BCA ASSESSMENT REPORT

**Oakdale Central Lot 3, Buildings 3A, 3C and 3D
Milner Ave Horsley Park**

Client: Goodman Property Services

REPORT STATUS				
DATE	REVISION	STATUS	AUTHOR	REVIEWED
15/02/2016	0	Preliminary Assessment – For DA submission	DG	TH

Figure 1 - Lot 3 Site Plan

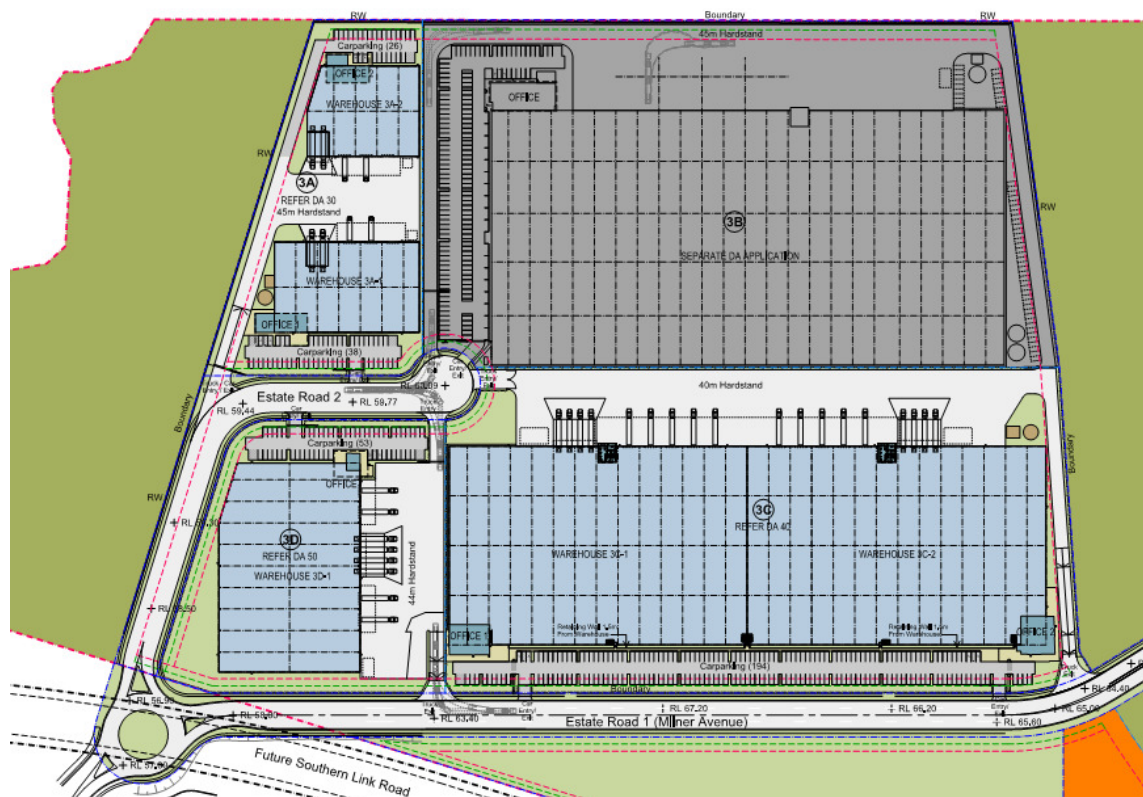
Comments: The proposed warehouse buildings do not comply with the provisions of C2.4 and thus the following non-compliance issues are required to be addressed as an

alternative solution by the Fire Safety Engineer to demonstrate compliance with Performance Requirement CP9 - refer to the dot points and the diagram below for details of the proposed non-compliance issues:

- + Lot 3A -1 – Vehicular Access is provided on the southern side of the building via the Estate Road 2 which is greater than 18m from the building; and the vehicular access is discontinuous in the NE corner of the building.
- + Lot 3A-2 – Vehicular Access is discontinuous on the NE & SE corners of the building.
- + Lot 3C – Vehicular Access is provided on the southern side of the building via the Milner Ave which is greater than 18m from the building and the NW & NE corners of the building the vehicular accessway is also greater than 18m from the external wall of the building.
- + Lots 3D – Vehicular Access is provided on the southern side of the building via the Milner Ave which is greater than 18m from the building and on the western & northern sides of the building the vehicular accessway via the Estate Rd No. 2 is also greater than 18m from the external wall of the building.
